Access Compliance Report

Public Rights-of-Way (Curb Ramps)

Intersection ID: 43374	Main Street: COOPER'S RIDGE LN	Cross Street: BERNBROOKE_SHADOW LN	Location: S
ADA ID: 83838E29C1C2	Ramp Type: BlendTrans1	Initial Pass/Fail: Fail	Overall Compliance: No
Severity Score: 21.25			
Codes/Mitigation Info/Possible Solution		Field Measurements/Component Compliance

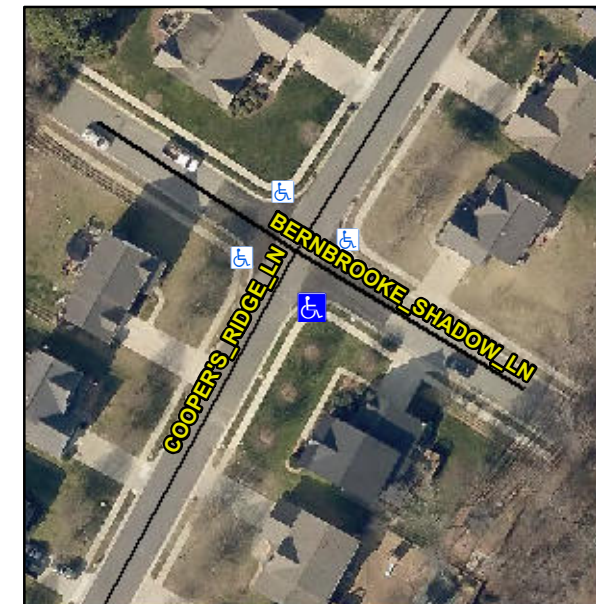
Not Found, R304.5.1, R304.5.3

Compliance	Description	Data	Compliance	Description	Data
N/A	Ramp Length (in)	48.0	Yes	BlendTrans Slope (%)	2.6
No	Ramp Width (in)	43.0	No	BlendTrans XSlope (%)	5.9
N/A	Flare Type LT	N/A	N/A	Flare Type RT	N/A
N/A	Flare Slope LT (%)	N/A	N/A	Flare Slope RT (%)	N/A
N/A	Flare Traversable LT?	N/A	N/A	Flare Traversable RT?	N/A
N/A	Landing Length (in)	N/A	N/A	DWS Provided?	N/A
N/A	Landing Width (in)	N/A	N/A	DWS Contrast?	N/A
N/A	Landing Slope (%)	N/A	N/A	DWS Length (in)	N/A
N/A	Landing X Slope (%)	N/A	N/A	DWS Full Width?	N/A
N/A	Landing Curb? (Y/N)	N/A	N/A	DWS Offset (in)	N/A
N/A	Shared Landing?	N/A			
N/A	Gutter Ponding?	N/A	N/A	Gutter Slope (%)	N/A
N/A	Gutter Lip Ht (in)	N/A	N/A	Gutter X Slope (%)	N/A
N/A	Painted X Walk1?	No	N/A	Painted X Walk2?	No
	X Walk 1 Direction	To NE		X Walk 2 Direction	To NW
	X Walk 1 Width (in)	N/A		X Walk 2 Width (in)	N/A
	X Walk 1 Slope (%)	0.6		X Walk 2 Slope (%)	3.5
	X Walk 1 X Slope (%)	4.9		X Walk 2 X Slope (%)	1.2

N/A	Ramp inside XWalk1?	N/A	N/A	Ramp inside XWalk2?	N/A
	Road Slope (%)	4.3		Clear Space?	N/A
	Road X Slope (%)	2.4	N/A	Clear Space to XWalk (in)	N/A
N/A	Any Obstructions?	N/A	N/A	Storm Grate/Utility Hazard?	N/A
	Obstruction Type			Storm Grate/Utility Type	
		N/A			N/A
			Yes	Surface Condition? (G/P)	Good
			No	Curb Slope (%)	10.0

Remove & Replace Curb Ramp With Two New Directional Ramps or Equivalent.
